STATE OF NORTH CAROLINA  
DEPARTMENT OF TRANSPORTATION

March 13, 2008

Subject: Request for Section 401 and Section 404 Individual Permit Modification and Permit Extension for Widening of US 15-501 from north of SR 2294 (Mt. Moriah Road) to south of SR 1116 (Garrett Road) in Durham County. Federal Project No. NHF-15 (8), State Project No. 8.1352301, Division 5, WBS Element No. 35012.1.1, TIP No. U-4012.

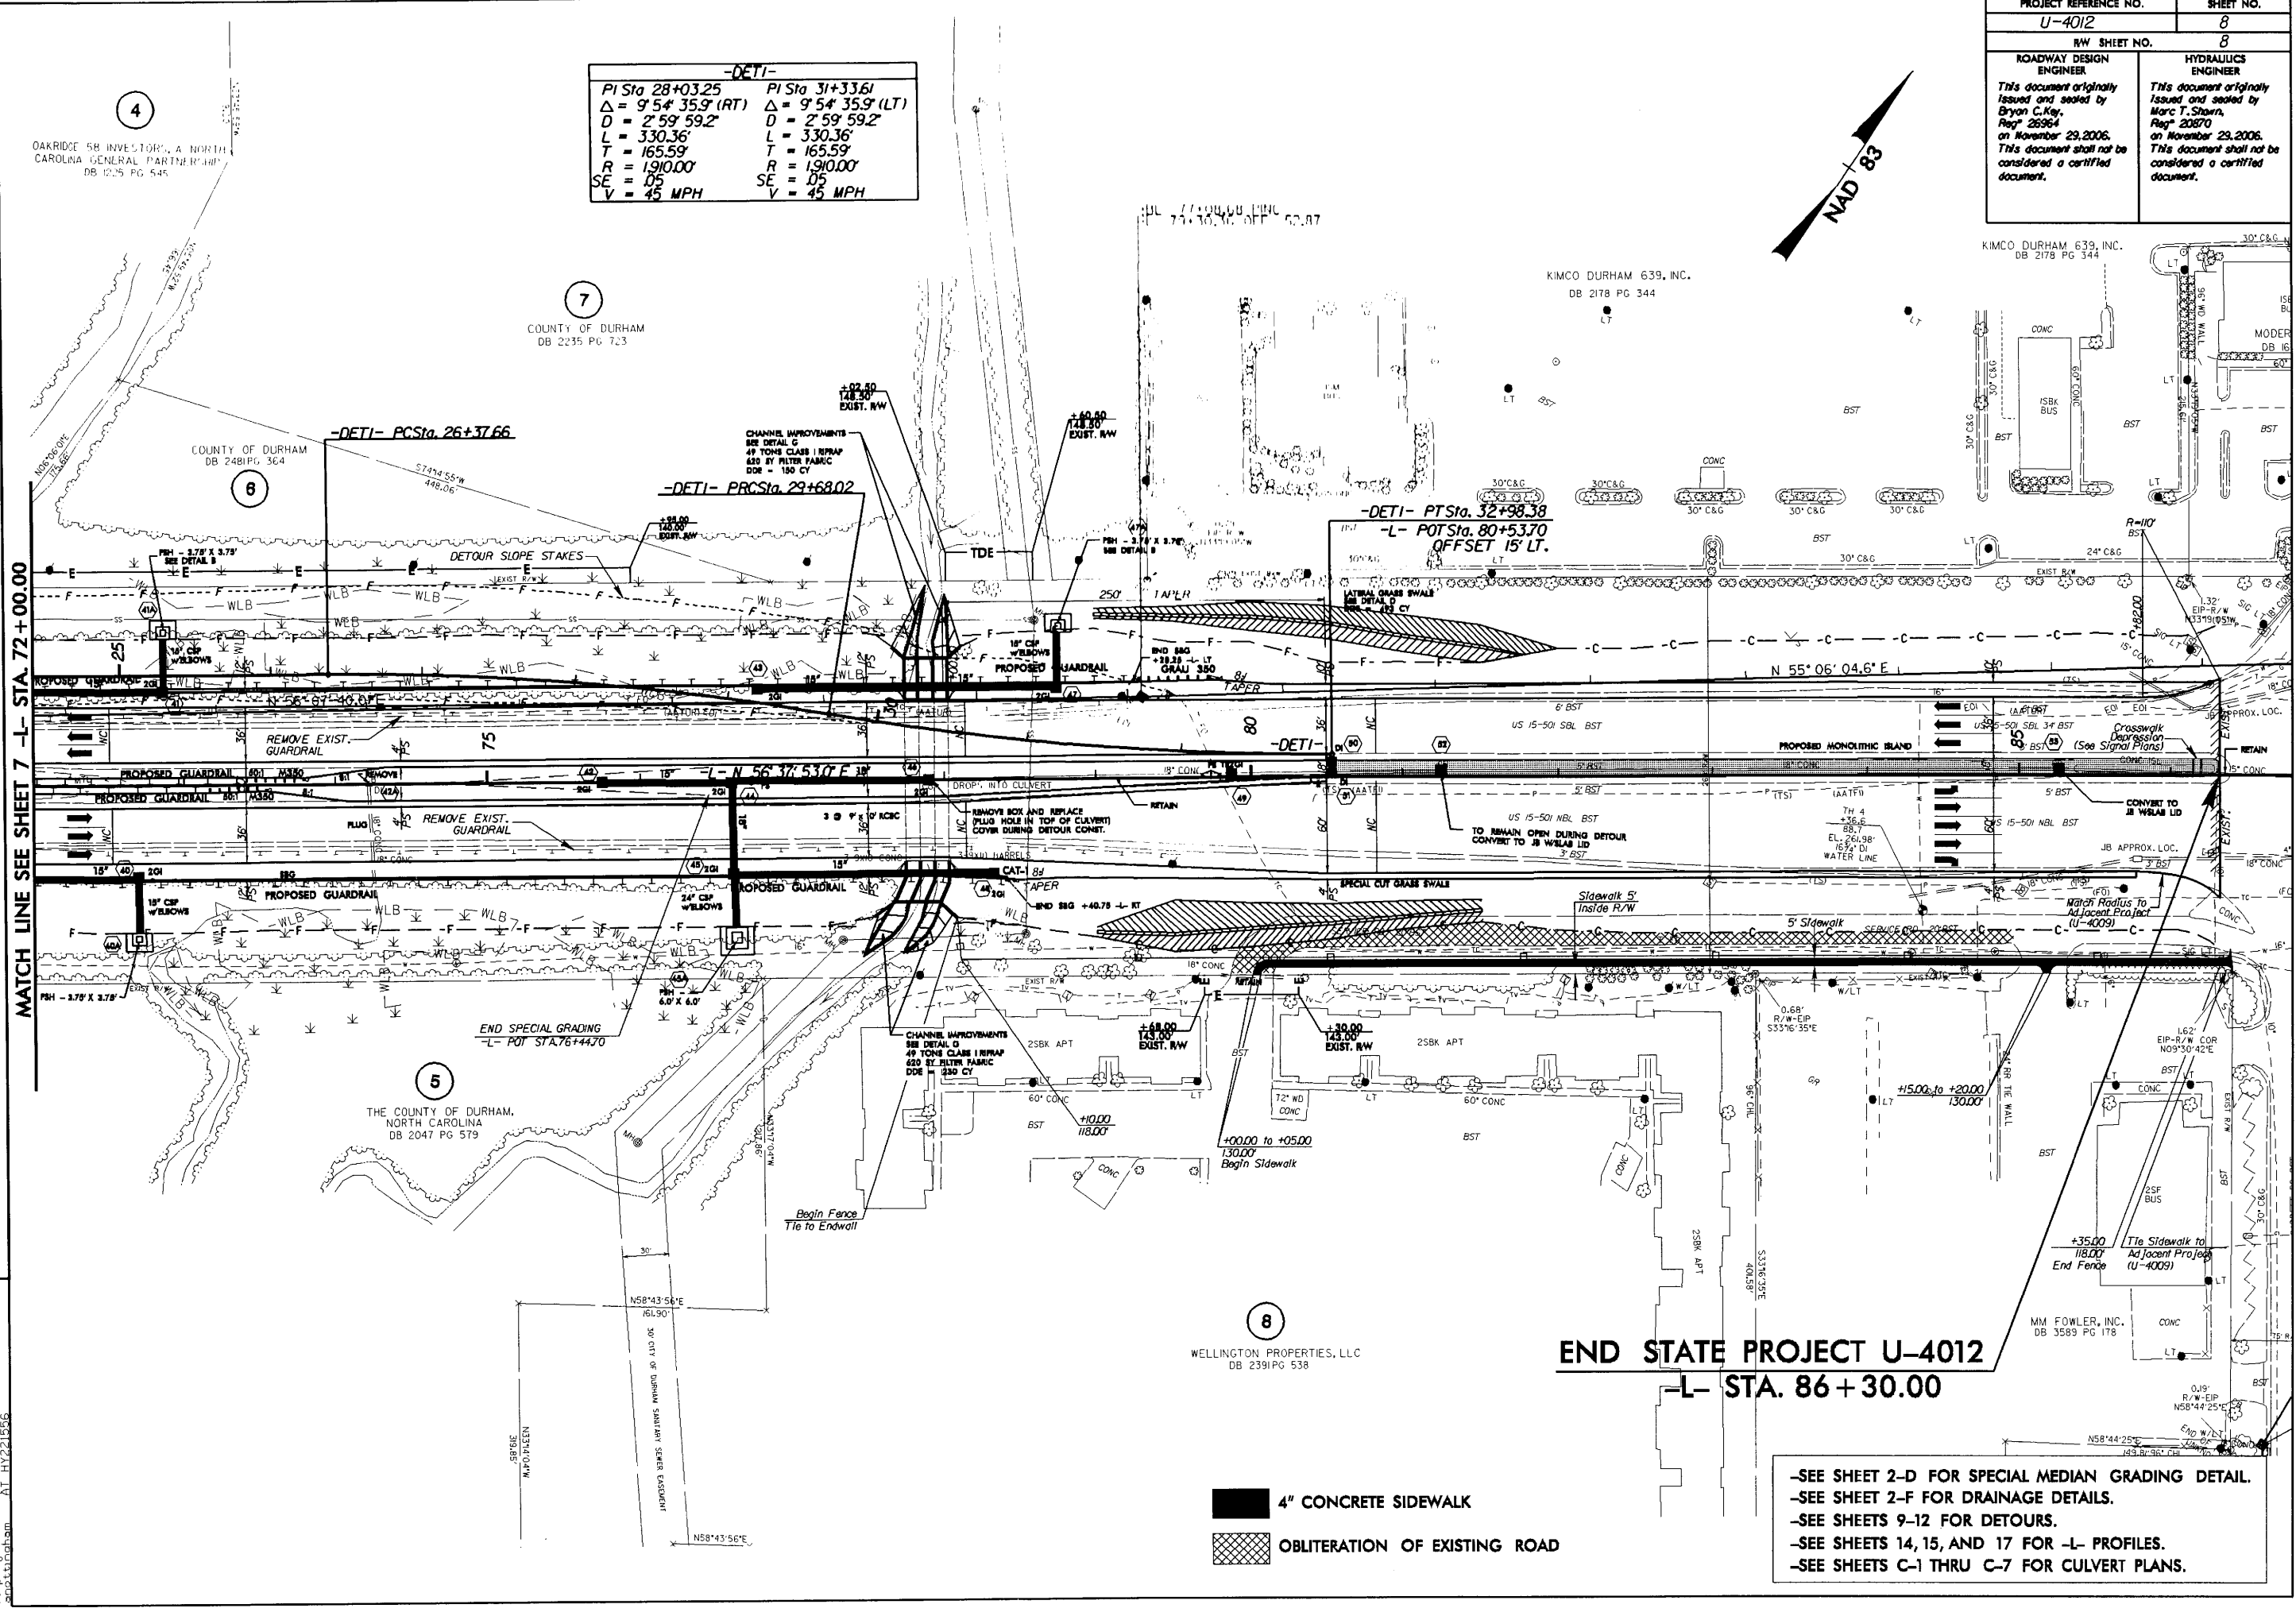
In the original permit drawings submitted, permit drawing 4 of 15 indicates that Special Cut Grass Swale (Detail C) is from 78+85 to 81+00 Rt. Plan Sheets 2-F and 8 indicate that Special Cut Grass Swale (Detail C) is from 78+85 to 81+50 Rt. The NCDOT Hydraulics Unit has indicated that the Special Cut Grass Swale (Detail C) should be constructed from 78+85 to 81+50 Rt. See the attached revised plan sheets 2-F and 8. This construction revision will not result in additional impacts to streams, wetlands or surface waters.

In the original permit drawings submitted, permit drawing 4 indicates that Lateral Grass Swale (Detail D) is from 79+00 to 81+00 Lt. Plan Sheets 2-F and 8 indicate that Lateral Grass Swale (Detail D) is from 79+00 to 81+50 Lt. The NCDOT Hydraulics Unit has indicated that the Lateral Grass Swale (Detail D) should be constructed from 79+00 to 81+50 Lt. See the attached revised plan sheets 2-F and 8. This construction revision will not result in additional impacts to streams, wetlands or surface waters.
